Device TC1762
Marking/Step EES-AC, ES-AC, AC
Package PG-LQFP-176-2

02971AERRA

This Errata Sheet describes the deviations from the current user documentation.

Figure 1

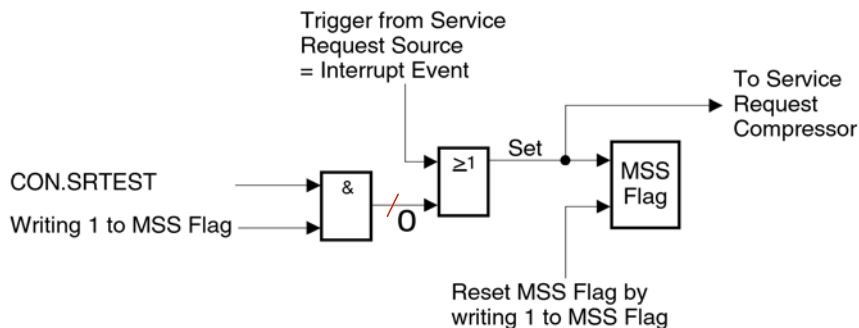
It is possible to generate a software triggered interrupt event in TESTMODE (`ADCx_CON.SRTEST=1`) by setting one of the bitflags in register `ADCx_MSS0/1`. Due to the fact, that this mechanism is not working, it is not possible to generate a corresponding interrupt by software.

Do not use this software-generated interrupt in TESTMODE.

Figure 2 Timing concerning equidistant multiple timers

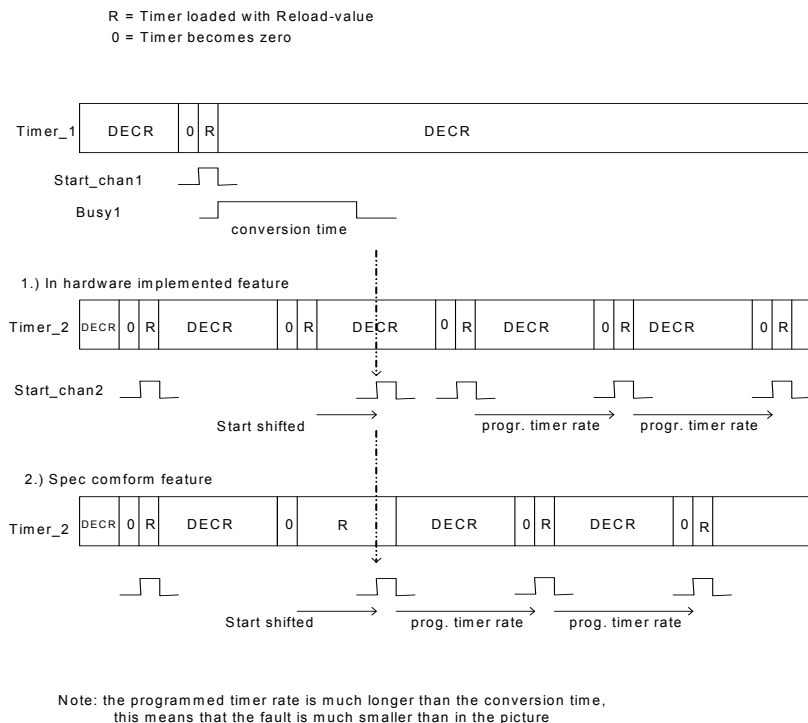
The correct behavior would be a reload when the requested conversion (of channel_2) is started.

Therefore the start of conversion for channel_2 is delayed by maximum one conversion-time. After this delay it will be continued with equidistant conversion-starts. Please refer to the following figure.

Figure 3 Uncritical transmission

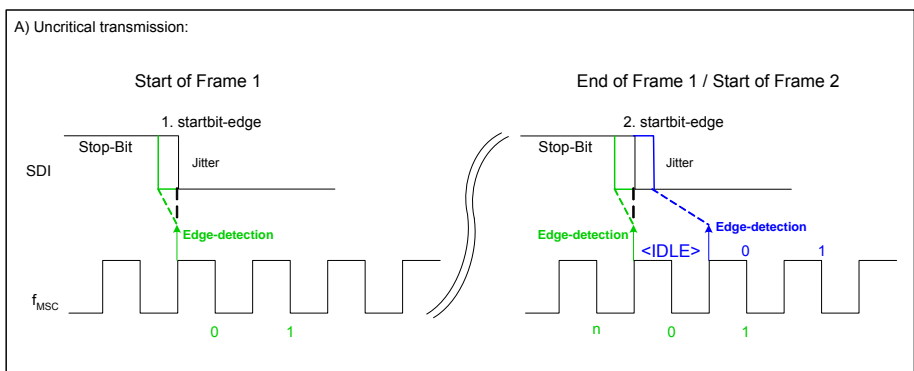
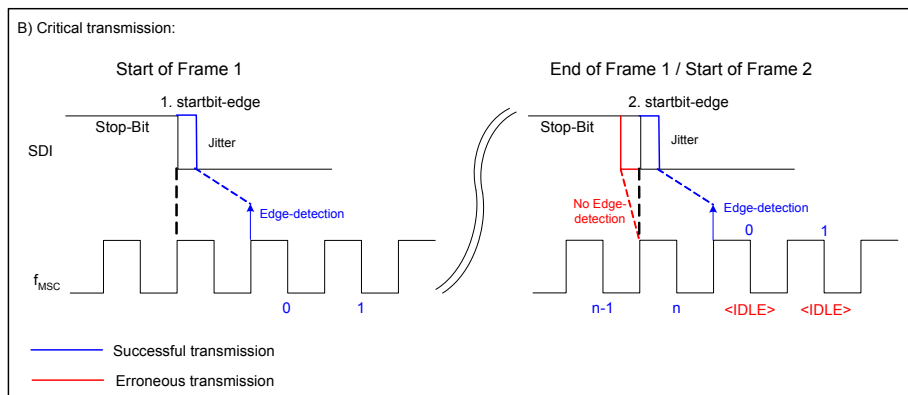
As the falling startbit edge is shifted to the left of the rising clock edge (**Figure 3** left), there occurs a secure detection of the next startbit edge in the last cycle of the previous frame (here cycle n, **Figure 3** right) independent from the applied jitter to this edge.

If the high-low edge of the start-bit in the first frame is just not detected by the near clock-edge (**Figure 4** - left) and the start-bit edge of the second frame is jittering to cycle n-1 (**Figure 4** - right, red coloured), then an erroneous transmission will take place. In this case the state-machine switches to IDLE after the last state n and wakes up on the next falling edge that may be a data-bit recognized as a start-bit. If the start-bit of the second frame is jittering to cycle n (**Figure 4** - right, blue colored), then the state-machine will not switch to IDLE but will start receiving the next frame correctly.

Figure 9 Current accuracy range
Workaround

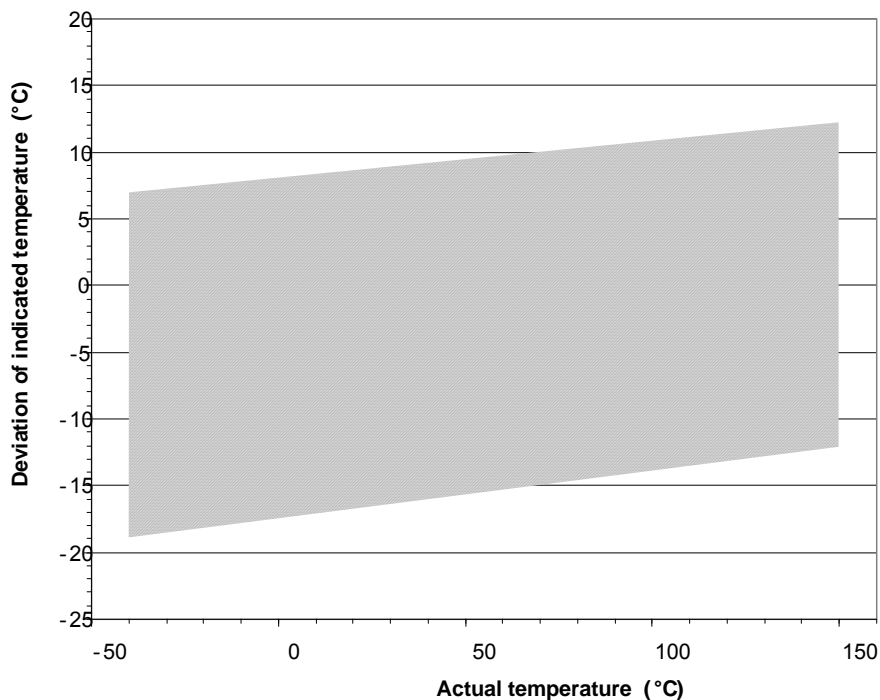
The accuracy of the DTS deviates from the values specified in the Data Sheet. The formulas available on the specification are as follows:

Figure 10 Exemplary power-up/down sequence

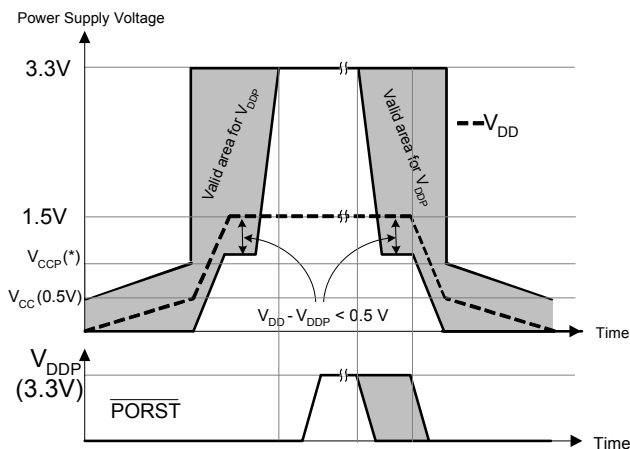
As per Data Sheet, $V_{DD} - V_{DDP} < 0.5\text{ V}$ has to be valid at any time in order to avoid increased latch-up risk. The figure below shows the possible V_{DDP} values as shaded region for an exemplary V_{DD} ramp. Moreover, the following rules apply:

- All analog voltages (V_{DDOSC3} , V_{DDM} , V_{DDMF} , V_{DDFL3}) must also follow V_{DDP} power-up/down sequence.
- V_{DDAF} , V_{DDOSC} must follow V_{DD} power-up/down sequence.
- The absolute value of the maximum allowed deviation between any two supplies is 0.5 V while the 1.5V supplies are below their specified operating conditions.
